UNITED WATER CONSERVATION DISTRICT

Re: Riverpark Draft EIR, SCH #2000051046

Riverpark EIR Response, Page 2

FIGURE 2-8

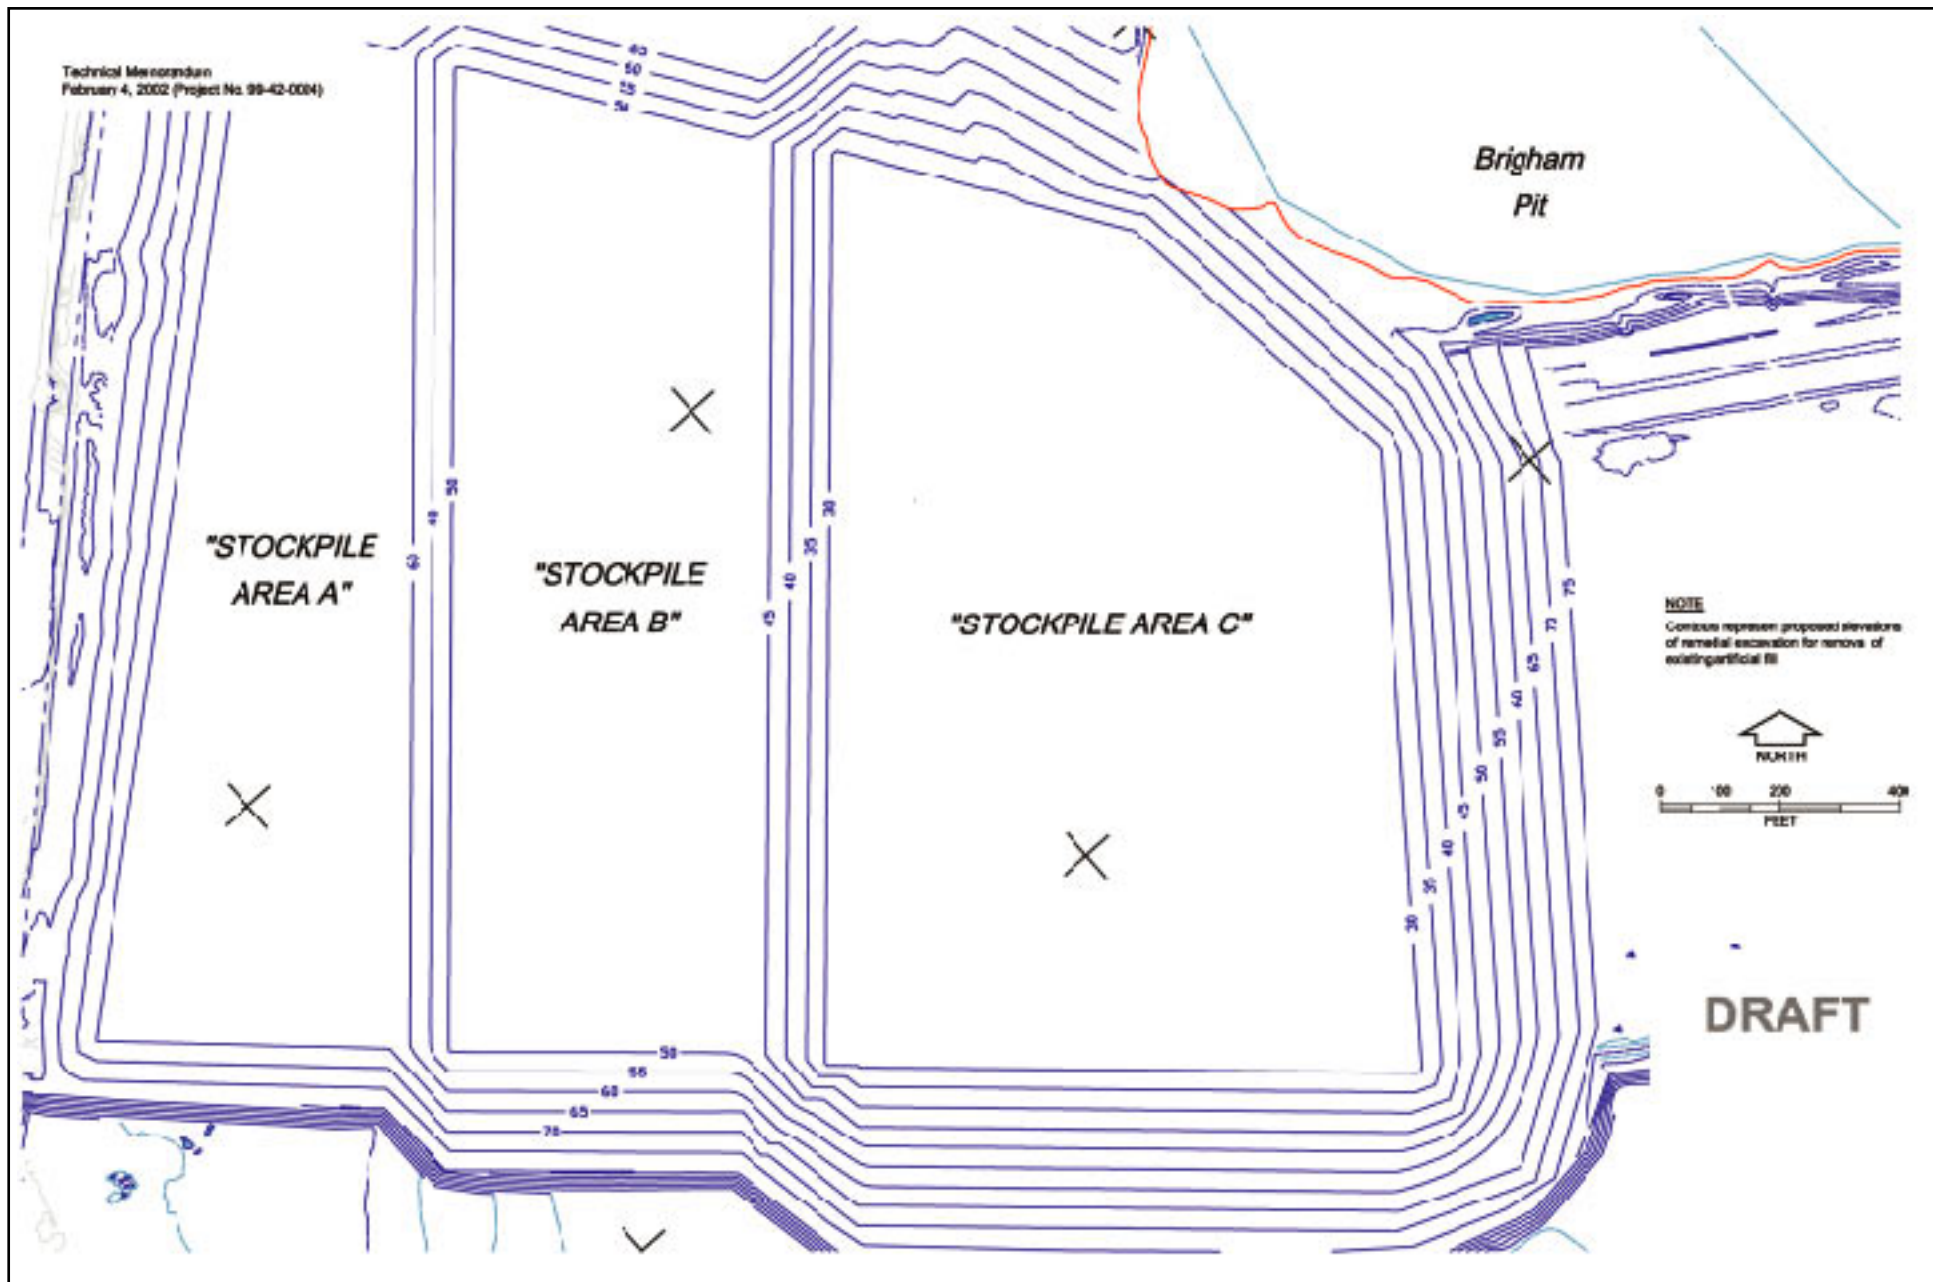
Comment: Effect of construction dewatering on MTBE, p. 4.5-85. The discussion should be updated and corrected. The discussion should correct the statement that groundwater modeling has shown that the pits will significantly dampen the effects from dewatering during construction – there has been no modeling of the dampening effects of the pits. It is very likely that such modeling would indicate that the dewatering, as proposed, would lower water levels in the pits sufficiently to accelerate the movement of MTBE from the contamination site.

Since the preparation of the DEIR, the area requiring dewatering has been refined and the proposed dewatering operation has been further clarified by Fugro (see attached **Figures 2-7** and **2-8** for area and previous extent of proposed excavation). The area requiring deep excavation (and extensive dewatering to approximately 20 feet above MSL) has been clarified and greatly reduced from approximately 37 acres to approximately 5.5 acres (approximately a 400 feet by 600 feet area) as represented by Area D on attached **Figure 2-9** (Fugro, 2002). The reduction in area has reduced the required dewatering period presented in the DEIR (page 4.5-70) from three to four months to approximately 55 days.
